TO: David D'Amico, Director of Public Services, Town of Medway
FROM: Michael Sanders, PE, Kleinfelder
DATE : 6/12/2019
SUBJECT: **Additional Water System Hydraulic Analysis for Timber Crest Estates Development**
CC: Kirsten Ryan, Kleinfelder; file

"TIMBER CREST ESTATES & KINGSBURY VILLAGE"
WATER CONNECTION PRESENTATION
IN
MEDWAY, MASSACHUSETTS

Figure 2: Fire flow node location plan (Not to Scale)

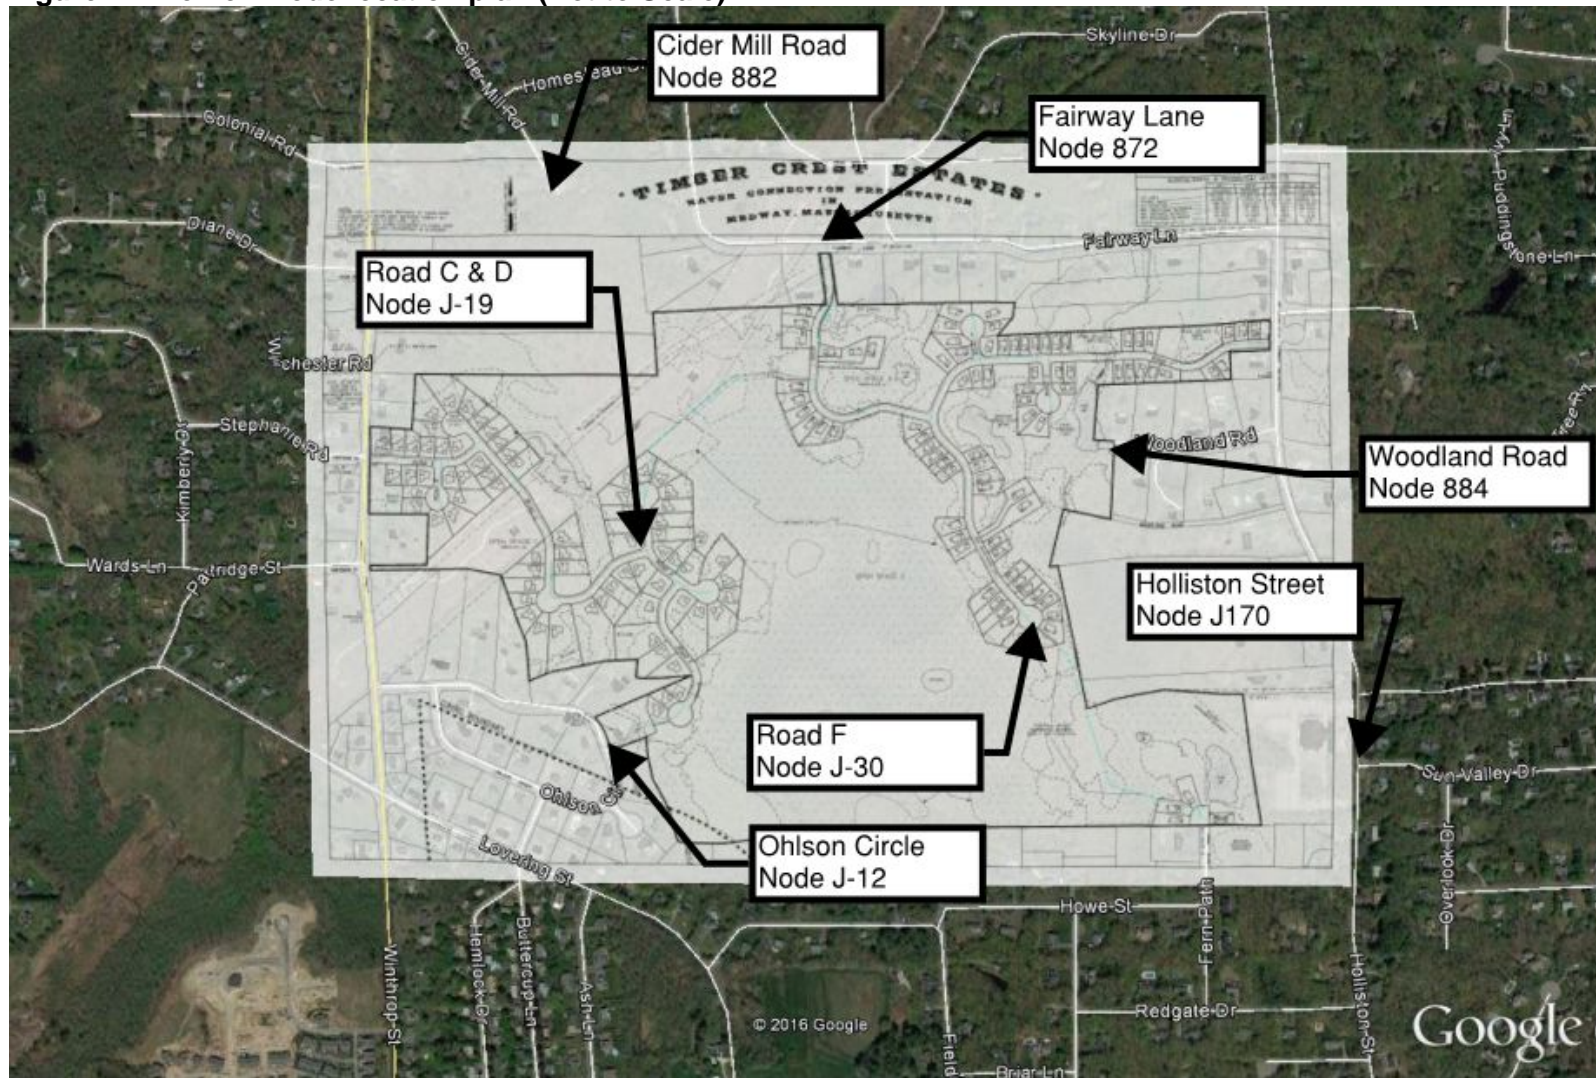
Table 3 above shows that available fire flow within the development is strongest under the scenario that includes both the east-west connection and the Fern Path connection; whereas; upgrading the water main in Holliston Street to 12-inch diameter pipe provides a major fire flow improvement to neighborhoods around the proposed development. The scenarios with the lowest available fire flow are existing conditions and the development scenario with neither the east-west connection nor the Fern Path connection.

If neither the east-west connection nor the Fern Path connection are constructed, the lowest available fire flow in the new development will be the end of Road F closest to Fern Path with 710 gpm. As described above, the needed fire flow for this type of development is 1,000 gpm. If the East-West connection and the Holliston Street upgrade are implemented, the recommended fire flow requirements would be met. Therefore, Scenarios IV, V and VII as described in Section 3 meet the recommended fire flow requirements:

If neither the east-west connection nor the Fern Path connection are constructed, but the water main on Holliston Street is upgraded from 6-inch to 12-inch, the available fire flow to the development and surrounding neighborhood will be increased. However, at Road F closest to Fern Path available fire flow will be 945 gpm which does not meet the needed fire flow of 1,000 gpm.

Kleinfelder recommends that the development include the improvements outlined in Scenario IV, V or VII as described in Section 3. That is, the Fern Path connection or the combination of the East-West connection and the upgraded Holliston Street water main to allow the Town's water system to deliver adequate fire flow to meet the site's fire flow requirements. Additionally,

Kleinfelder recommends that the developer mitigate the anticipated low domestic water pressures in this area. For example, installing a booster pump station in each home or a single, larger system to serve the entire development will increase system pressure above minimum standards. A single, larger pump station will have long-term operation and maintenance requirements and the Town would not take ownership of such a system. Therefore, the individual booster pumps appear to be the only viable solution to address low pressure.
